Project:	Fraser House	Eng:	MWS
Title:	Fourth floor structure	Date:	May'23
No:	LM21346-DYSE-XX-ZZ-SK-S-0026	Rev:	P03

Fourth Floor Structure Indicating Roof Structure Over

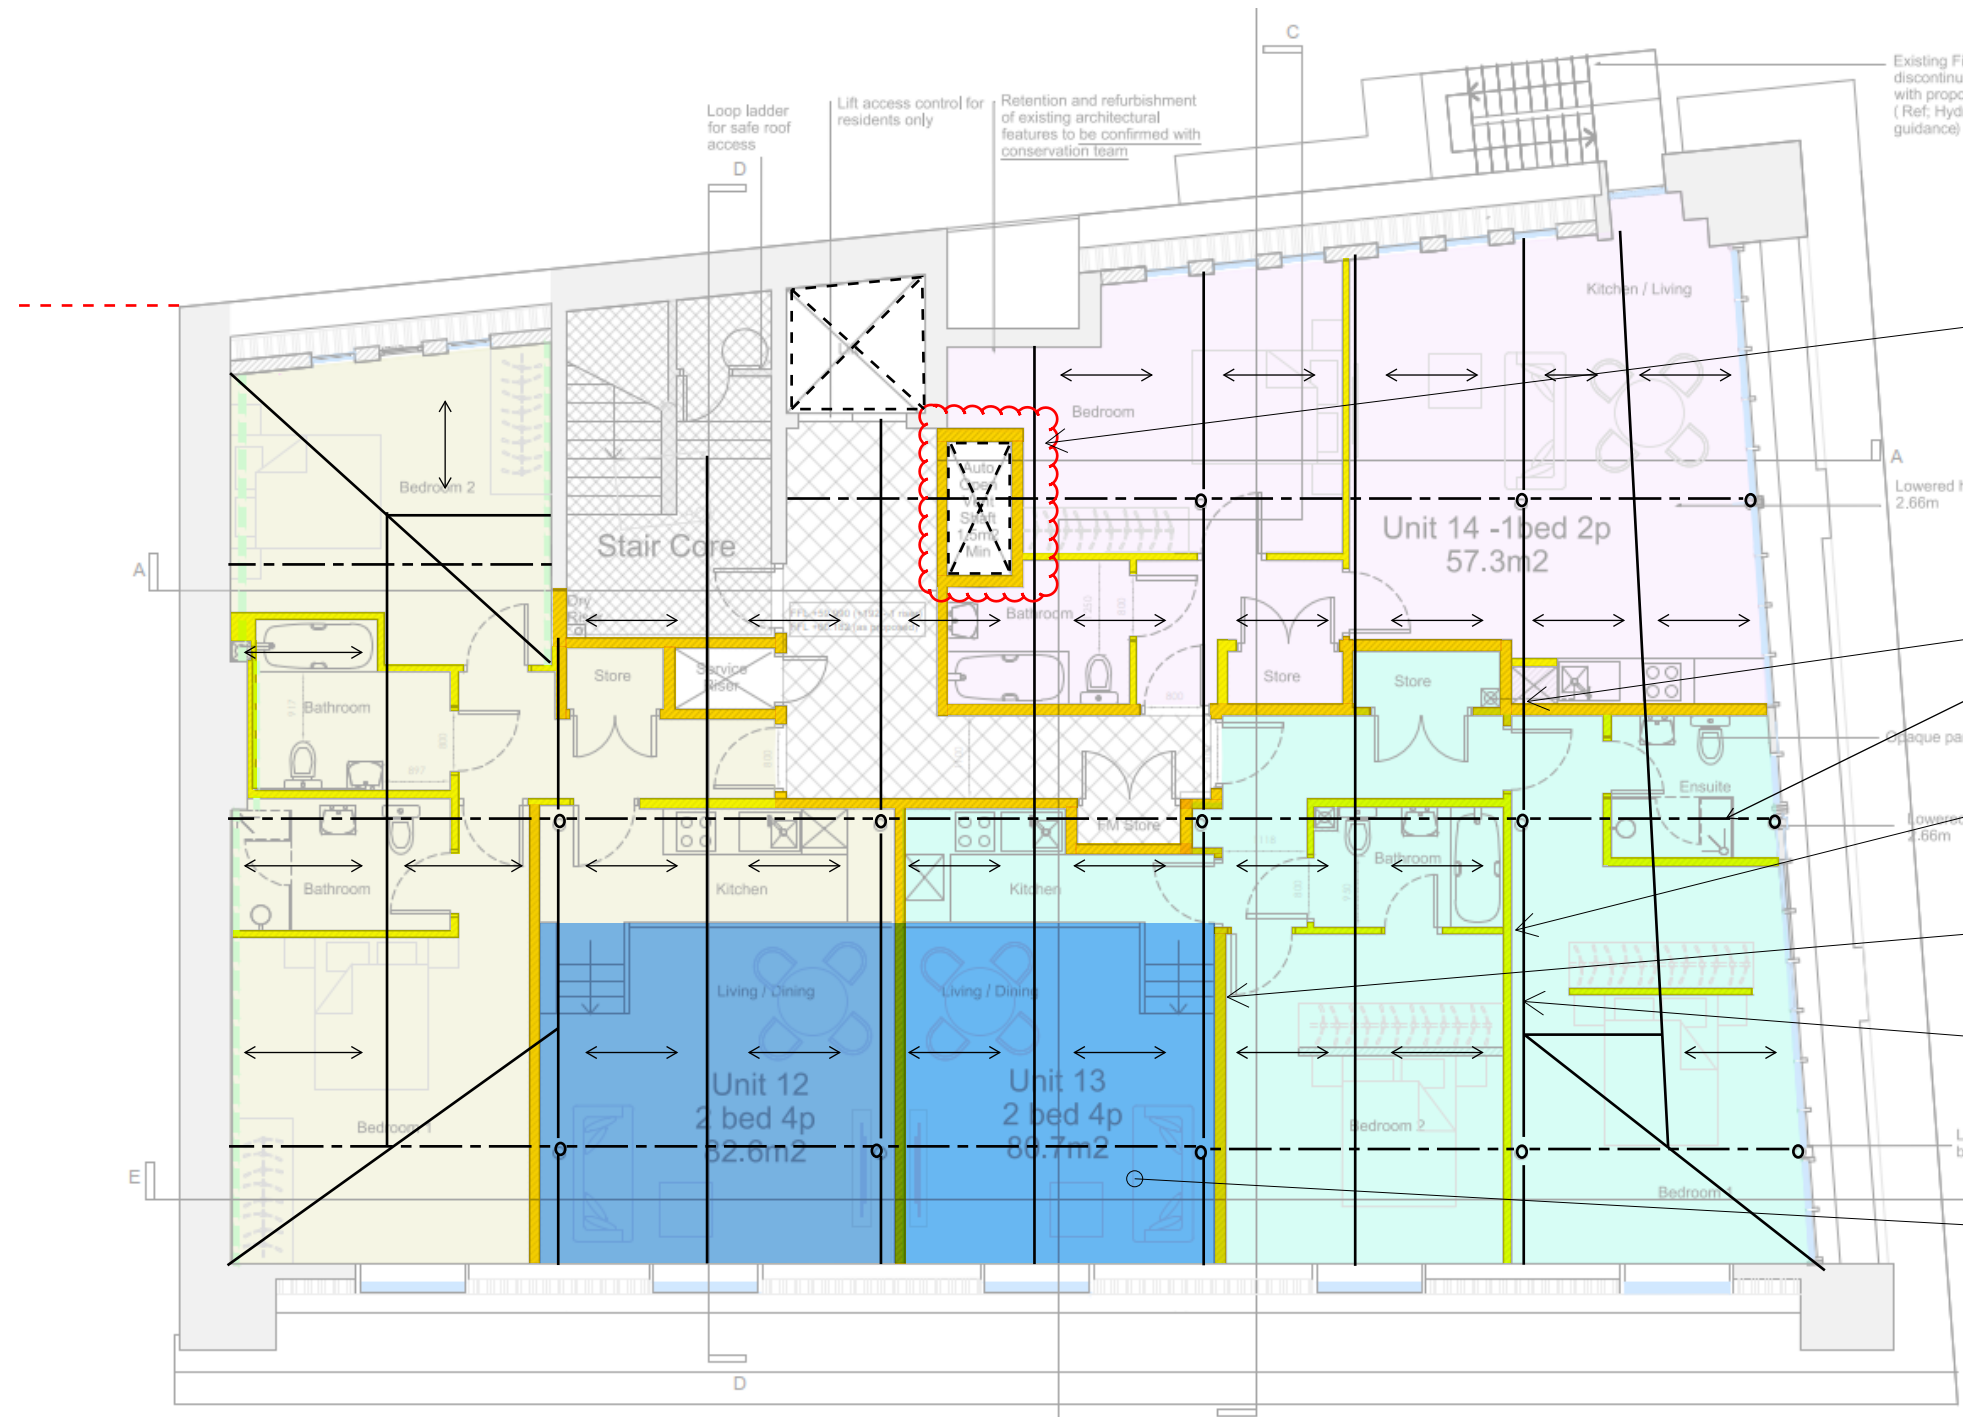
Location of smoke vent cuts through existing roof purlin. Can smoke vent be moved to avoid additional significant structural framing to trim out void for smoke vent. Vent within roof to be trimmed out with new structural timber. Architects to confirm acceptance.
